March 30, 2022

RE: Sunridge Villas (Sundance) Design Review (PLND-0322-0029)

RE: Sundance (DD9708)

RE: Sundance Resubmittal (DD9708)

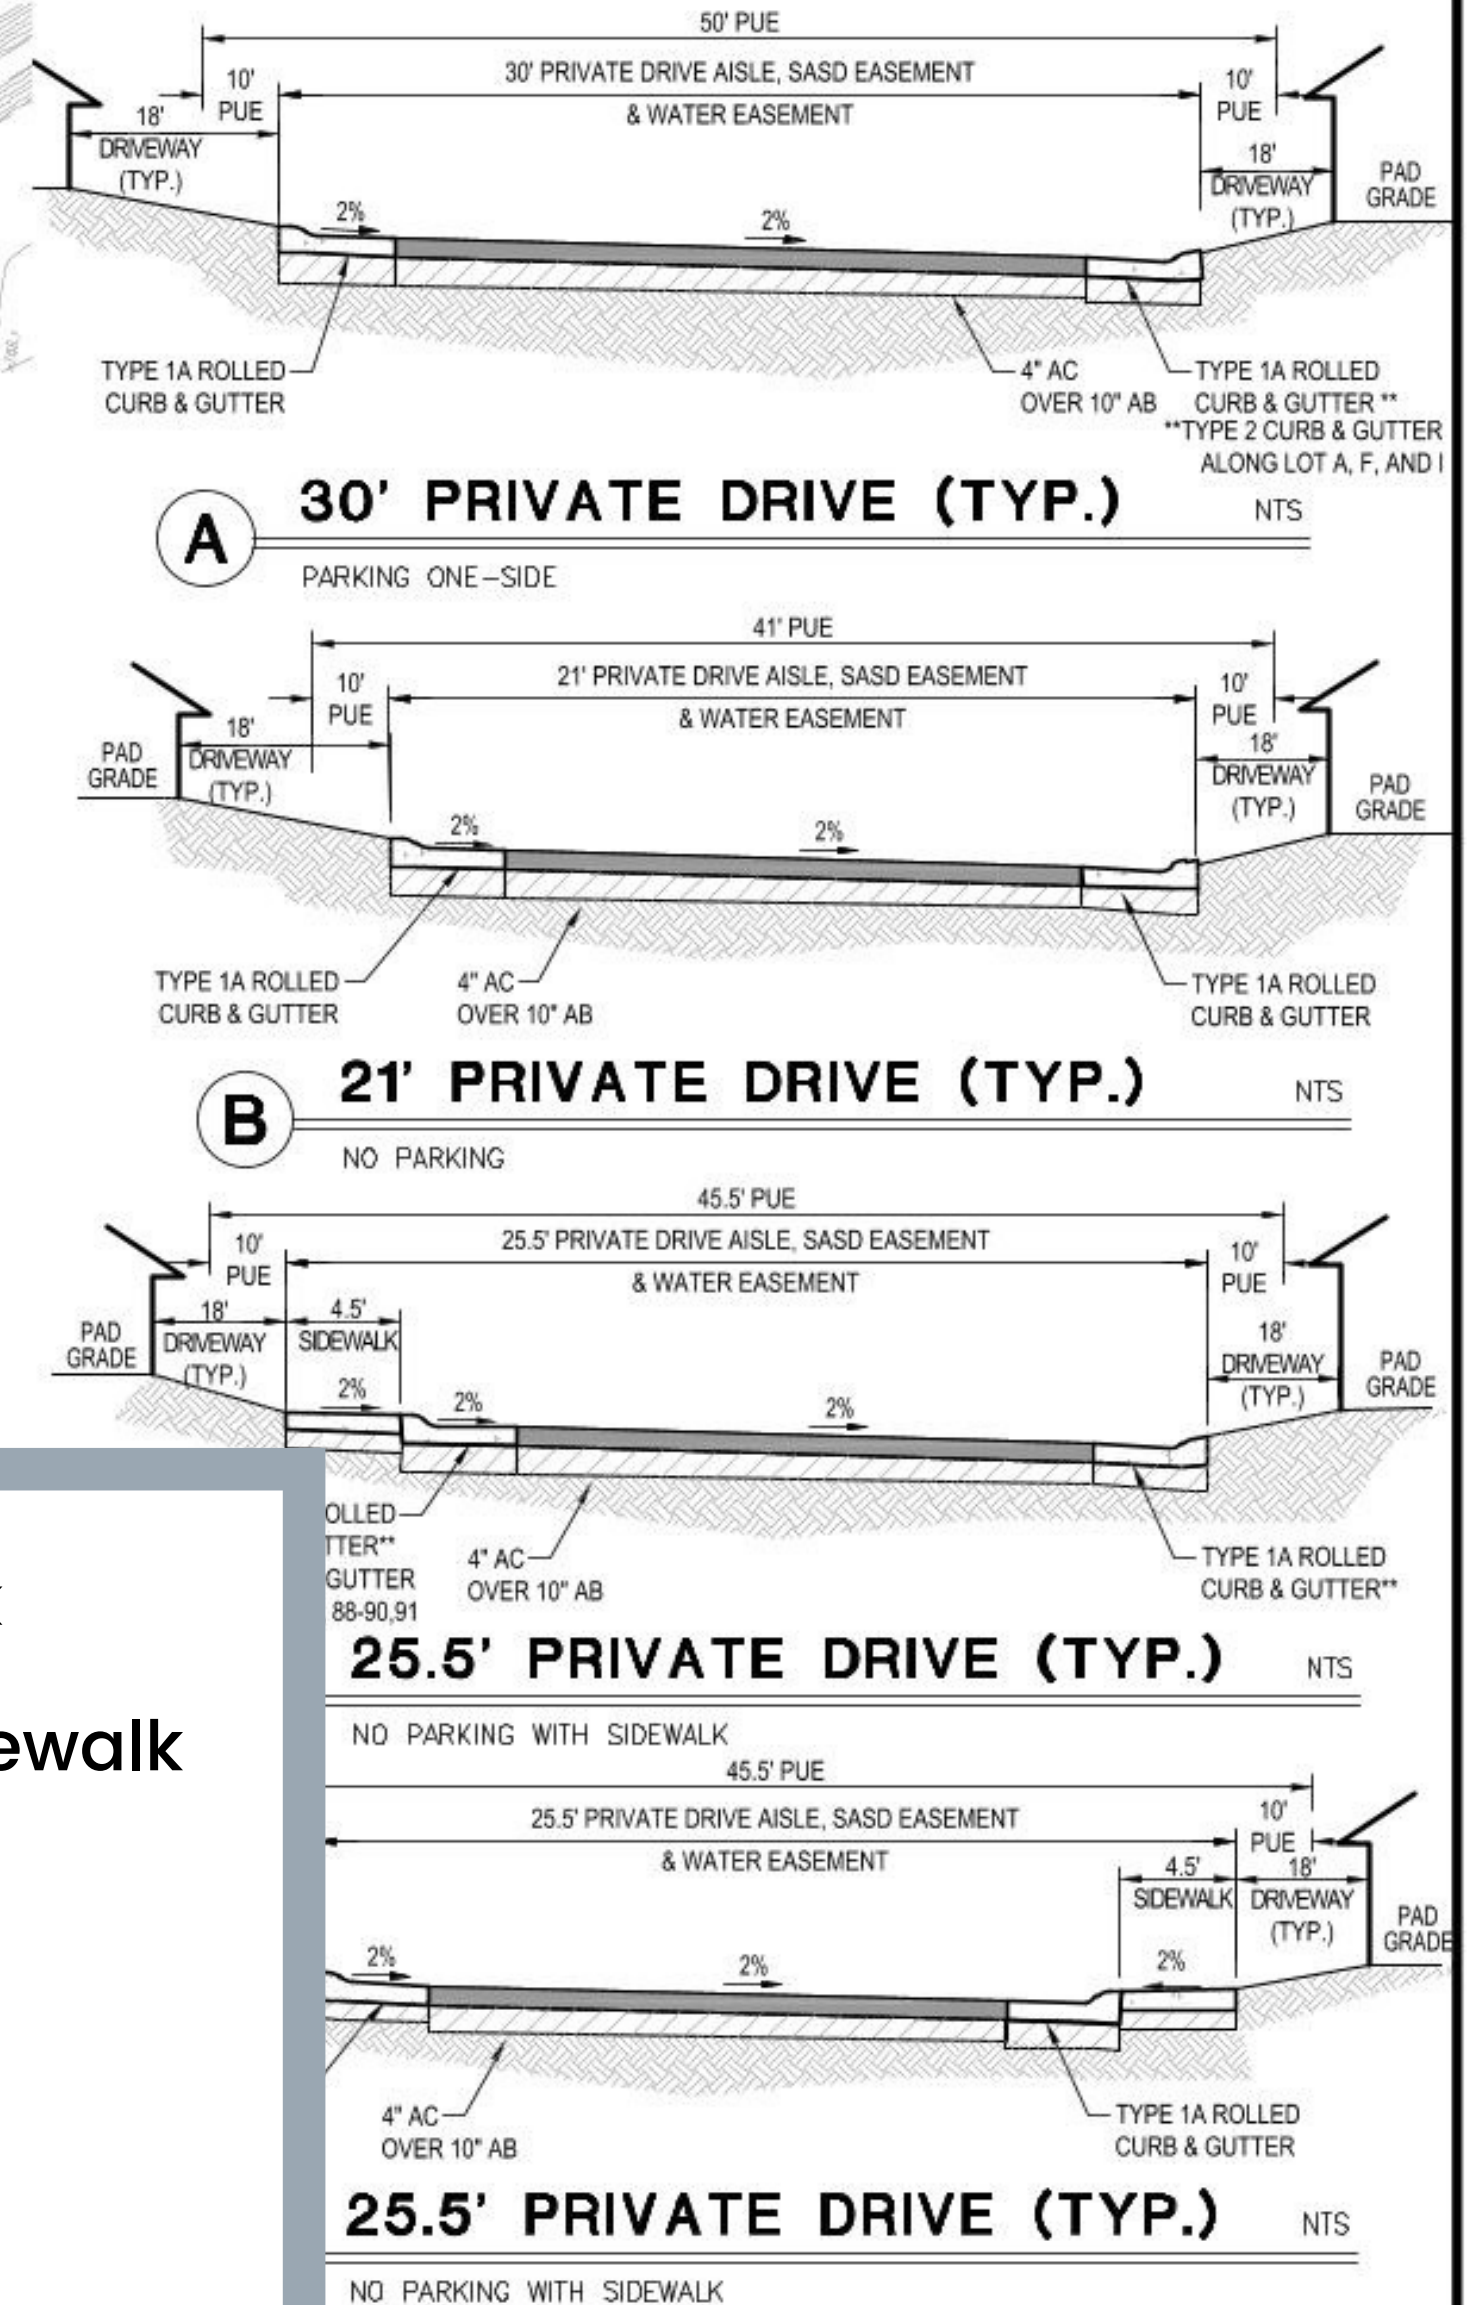
Please also see our proposed sidewalk additions in the attachment at the end of this letter. The orange dashed lines denote sidewalks that should be put in to improve pedestrian safety. Drivers entering the development or driving along a straight road, such as along "A" Drive, are more likely to purposely or inadvertently drive faster than a 5-10 mph speed that is safe for pedestrians, thus making sidewalks on both sides necessary to prevent jaywalking or walking in the street. The purple dotted lines are areas for which sidewalks would greatly improve connectivity. We understand that putting in continuous sidewalks on every street may not be feasible at this stage. If this is the case, the streets must be designated as pedestrian spaces because pedestrians will need to use the street to access sidewalks that do exist. To achieve this, we recommend the following:

- **At a minimum each street should have a sidewalk on one side (for example, “B” Drive currently does not have a sidewalk proposed on either side).**
- **Tighten all corner radii to 10’ or 15’ to slow traffic to safe vehicle speeds.**
- **Include street markings that indicate the streets are shared spaces.**
- **Construct the two largest internal intersections (both located on “A” Drive) as raised intersections to slow vehicles.**

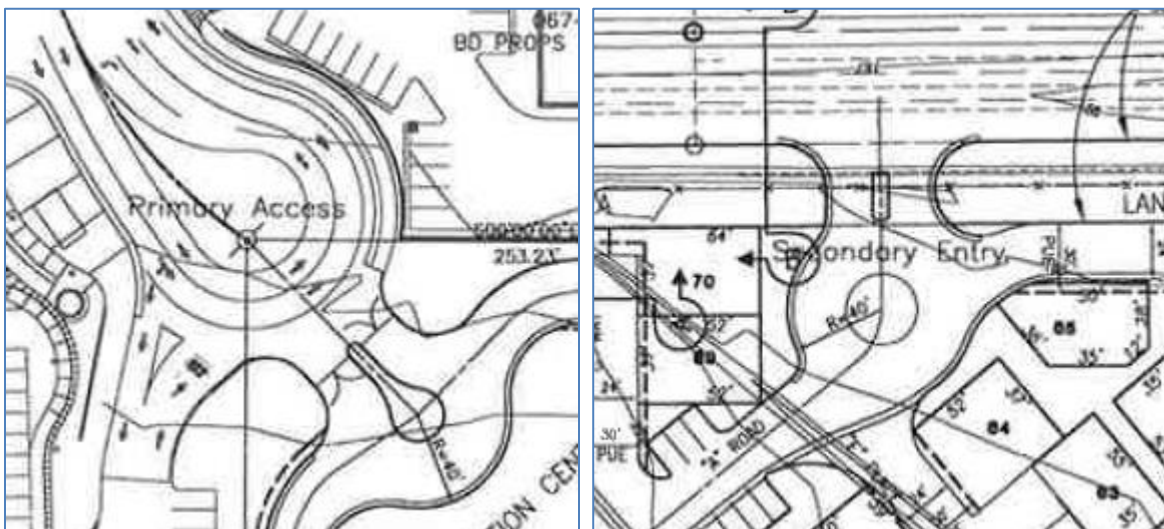
The major change to the project that would affect pedestrians is the inclusion of sidewalks on some of the private street segments. While constructing sidewalks in front of 20 of the 114 house lots will provide a safe path of travel between the two subdivision entrances, the issue of accessibility remains for the remaining 94 houses. This is because there will be a rolled curb between the driveway that will be the walkway to the house and the street that will be the walkway to everywhere else.

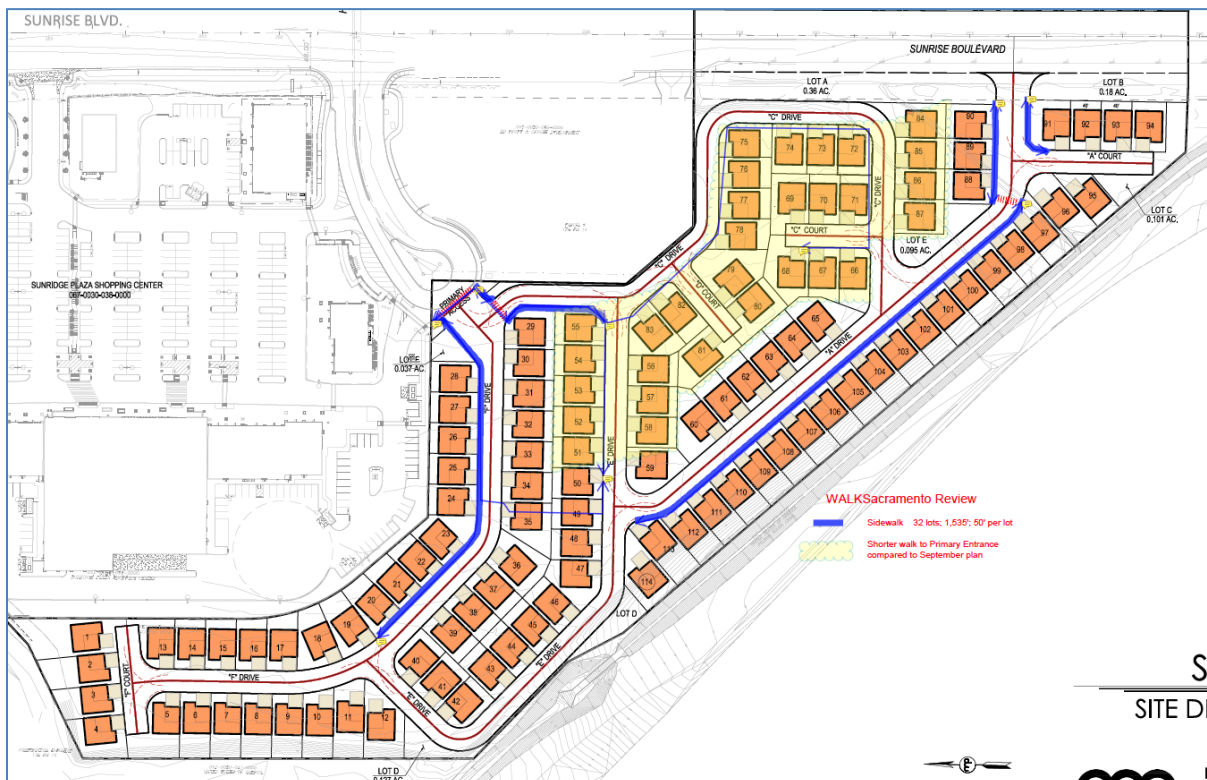
The original site plan, from August, appears to provide better pedestrian access than the revised plan. The splitting of the “j-shaped” block near the center of the project site and elimination of the street segment between the block and the Walgreens site creates much longer walking distances from many of the house lots to the adjacent Sunridge Plaza (Raley’s) and Walgreens shopping centers. The diagram below uses yellow shading to indicate the lots for which we believe walk distances to Raley’s would be shorter with the original plan compared to the revised plan. The blue lines show sidewalk locations. Note the long, straight section of sidewalk. This arrangement could also be incorporated in the revised plans. One benefit to this would be a significant increase in the number of houses that have sidewalks.
